ALTO PRODUCTS CORP.

New Product Release

**Mitsubishi / Hyundai / Chrysler / Overdrive Clutch PowerPack Kit
With Apply Piston "D" Type Sealing Rings
Alto# Part No. 059935PWR**

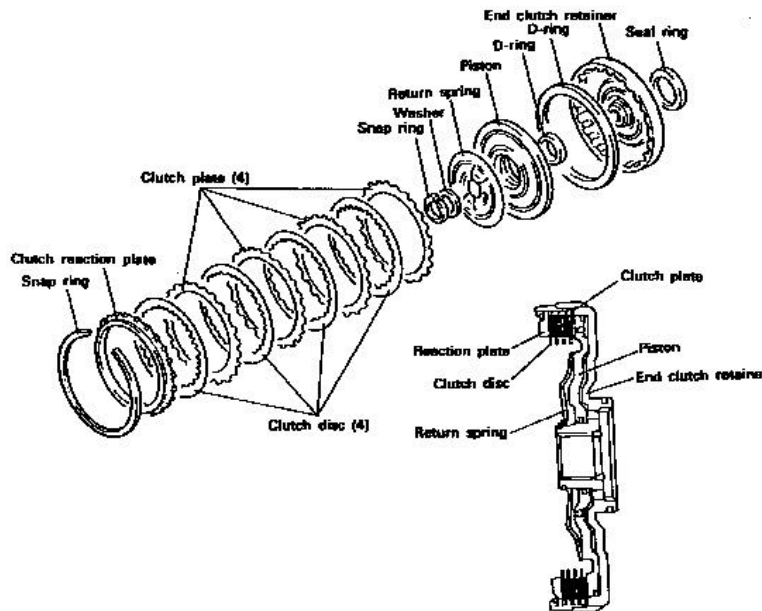
Problem: Many reports of premature clutch failure are caused by the fact that the OEM dimension of the steels is too thin to dissipate the heat during clutch engagement. Any heat that is applied to the steels will cause the steels to distort and/or warp and cause premature Overdrive clutch failure. Also, the OEM type apply piston lip seal is extremely difficult to install, causing the lip to fold under and lack of hydraulic pressure to the end clutch.

Solution: Alto kit #059935PWR contains all of the components to repair the Overdrive clutch. The steel thickness has been increased by 48%. This will prevent steel plate distortion. The addition of the "D" ring to this kit allows easy installation.
